PCN #: 2024-07_EnOcean_Package_Label_Update
Change Title: EnOcean Package Label Update
Date of publication: July 10th, 2024

Description of change

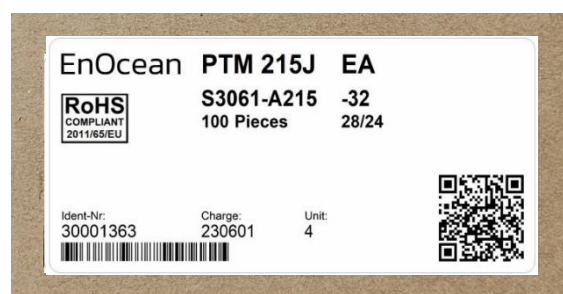
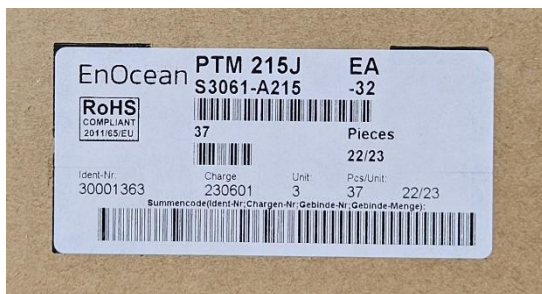
EnOcean multi-unit packages contain a product label which are used to identify key product parameters to our customers and to facilitate handling at EnOcean warehouses. The pictures below show an example of a packaging label on a 100-unit box of PTM 215 modules (on the left) and an example of a packaging label on a sealed reel of TCM 310 modules shown below on the right).

These packaging labels will be modified to improve traceability and handling for our customers and at EnOcean warehouses.

The current package labels (an example is shown below on the left) contain machine-readable information provided by a set of one or several 1D bar codes which restricts amount and format of available information and requires precise scanner alignment. The information in those labels was only intended for use in EnOcean warehouses.

The new package labels (an example is shown below on the right) will use one QR code to encode key product parameters, thereby eliminating the need to consecutively scan several 1D bar codes.
